**Re: Proposed Official Plan Amendment OPA 20/004 and
Zoning By-law Amendment ZBA 20/012
660 Belmont Avenue
GSP Group on behalf of 660 Belmont LP
CITY OF KITCHENER**

Date: August 20, 2020
To: Julianne vonWesterholt, Senior Planner
From: Dayna Edwards, Senior Planner (Urban Design)
Subject: Application Comments (OPA/ZBA/SP)
660 Belmont Ave West

Date: September 2, 2020
To: Juliane Von Westerholt
From: Jason Brûlé
cc: Linda Cooper
Subject: Zoning By-law Amendment and Official Plan Amendment Application
660 Belmont LP Inc.
660 Belmont Avenue West, Kitchener
ZBA 20/012/B/JVW
OPA 20/004/B/JVW

**City of Kitchener
OPA/ZBA Comments**

Built Form Massing:

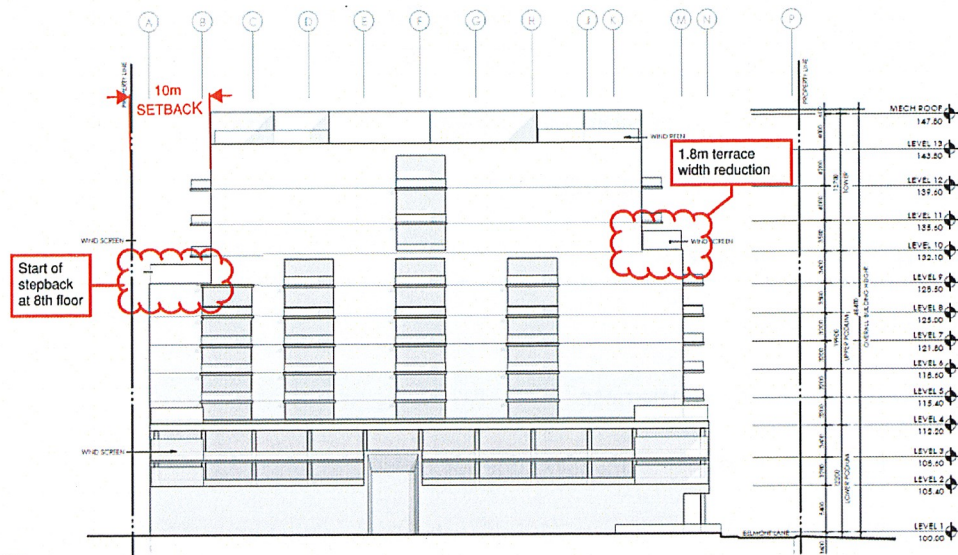
Having reviewed the Urban Design Brief there is specific reference to current City of Kitchener Tall Building Design Guidelines (TBDG). The current building as designed does not meet the TBDG standards.

The separation distance calculated and noted within the urban design brief is 10.0m (which appears to be correct given the information provided in the brief reviewed by staff). The brief notes a proposed separation distance of 8.2m for levels 10- 12 and 2.0m for levels 5-9. Staff have reviewed the stepbacks and propose the following.

That the step back be introduced at the 8th rather than the 9th level to create a better transition to the adjacent property when it redevelops. This would also create less shadow impacts to adjacent properties and the iron horse trail when the adjacent property develops as a similar separation distance would be imposed through future development.

The step back of 10m (as calculated through the TBDG) would be provided from floors 9 through 12. The 9th floor north terrace would increase from 8.2m to 10m (1.8 m increase in width) the south terrace would decrease from 5.7m to 3.9m. An image of the proposed change is provided below for reference.

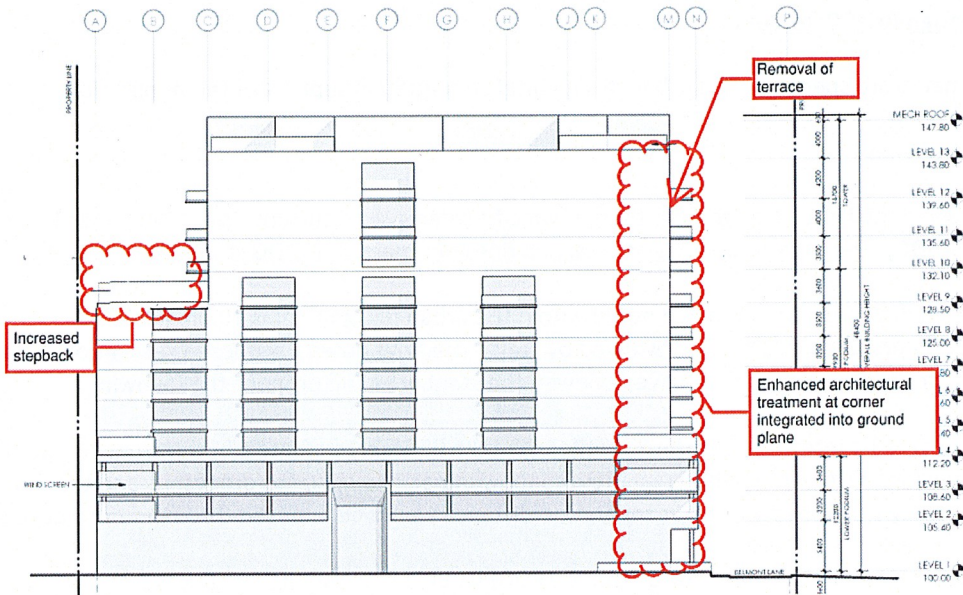
The size and mass of this building will make it a gateway to Belmont village. Staff request that the applicant consider shifting the massing and creating an enhanced street facing corner elevation to further accentuate the gateway into Belmont village. This would eliminate the terrace feature on the south elevation but create an opportunity for an enhanced corner treatment that could connect directly to the ground plane (see image below) with terraces wrapping the building corner.

Staff would be supportive if either design solution as both achieve the intent of the Tall Building Design Guidelines.

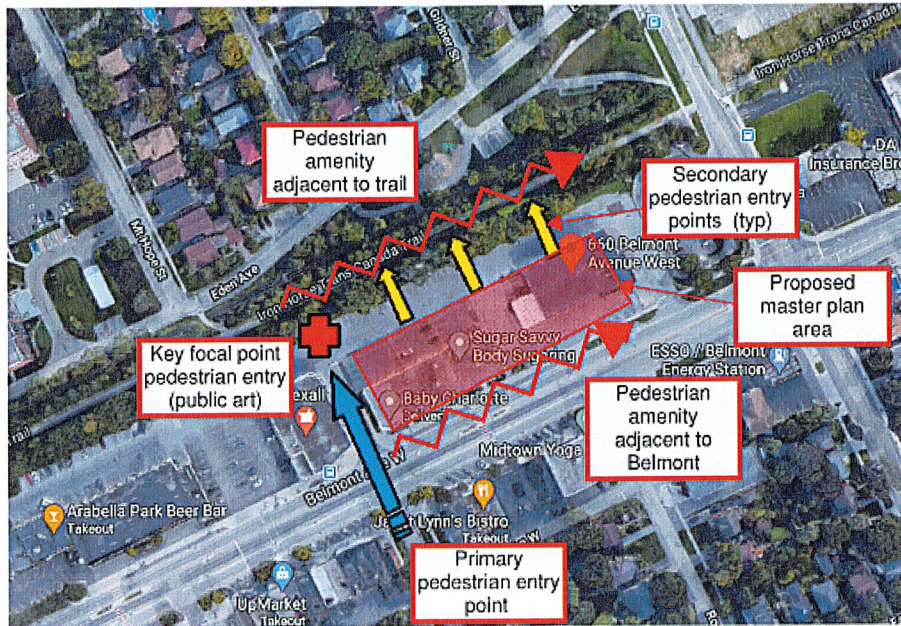
During the pre-application process the owner noted that there was an interest in developing a landscape masterplan to address the Iron Horse trail for their properties at 660 Belmont Ave W and 678-692 Belmont Ave W. Through internal conversations with Parks and operations staff it was determined that it was desirable to address the Iron Horse trail through a landscape master plan as well.

The existing trail interface is not conducive to pedestrian movement due to the existing parking and laneway location, overgrown vegetation, long blank walls and lack of pedestrian access.

The figure below notes a masterplan area as well as a general overview of areas of potential focal points, pedestrian access and amenity along the street and trail edge.

The terminal view down Claremont through the site presents an opportunity for a bold vertical element such as a public art piece that would serve as focal point and wayfinding element along the trail.

Approximate area of proposed lane closure/sale

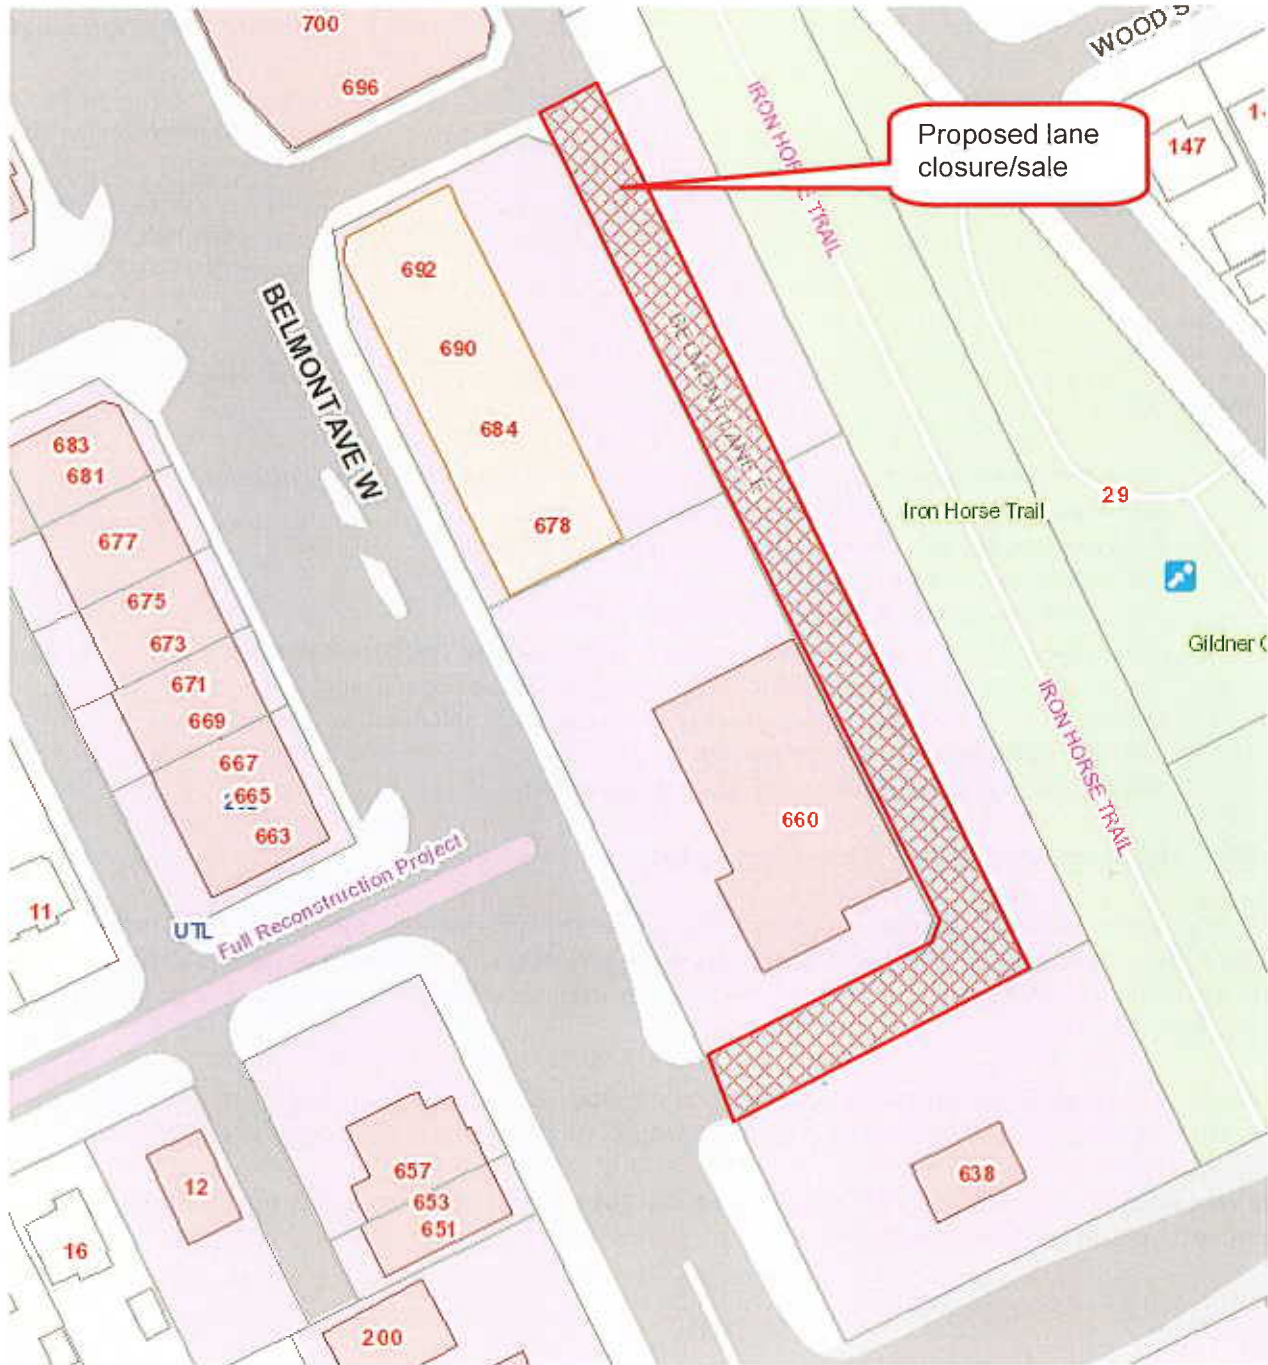
The lane appears to contain the sanitary and storm servicing for properties addressed on Belmont. Additionally, records show the sanitary from Rock Ave outletting through 660 and the laneway.

Any disposal of this land (laneway behind 660) would require review and likely rerouting of the sanitary.

Regarding the closure of the portion behind 678-692, I have no concerns provided the underground infrastructure in this laneway is accessible and there is ample space to turn around with a maintenance vehicle.
